Product Change Notification / SYST-28ROFM428

ERRATA - PIC18F26/46/56Q43 Silicon Errata and Data Sheet Clarifications Revision

PIC18F26/46/56Q43 Silicon Errata and Data Sheet Clarifications

1.7.1 UART TXDE Signal May go Low Before The STOP Bit Has Been Entirely Transmitted.

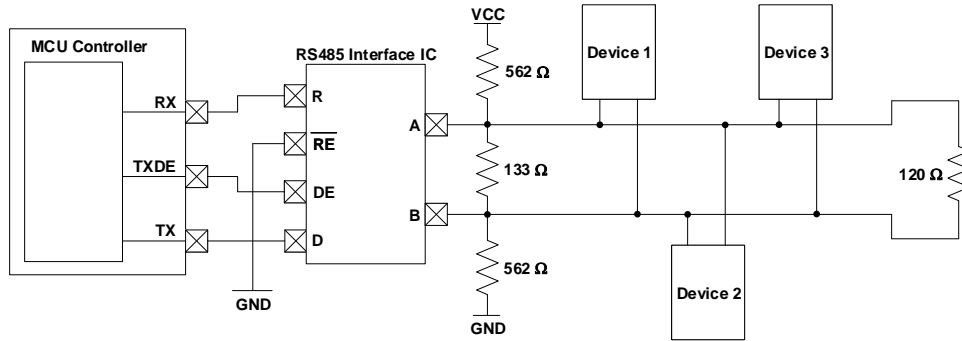
The UART Transmit Drive Enable (TXDE) signal could potentially transition into a low state before the UART STOP bit has been entirely transmitted due to the effects of parasitic capacitance on the TX line. In some applications, this could result in communication being prematurely terminated due to the TXDE bit going low before the STOP bit has had enough time to settle.

In order to ensure that the STOP bit settles into its final logic state before the TXDE signal transitions low, a biasing circuit can be implemented. A biasing circuit allows the TX line to either be driven high or low, rather than being left in a floating tri-state mode where prolonged rise or fall times could lead to communication being disrupted. This bias circuit should only be implemented on one end of the serial bus, and a termination resistor should be used on the other end. The figure below show an example of a bias circuit that can be used to achieve this.

Please note that the resistor values used in this circuit are recommendations, and that the actual resistor values required may vary based on the application.
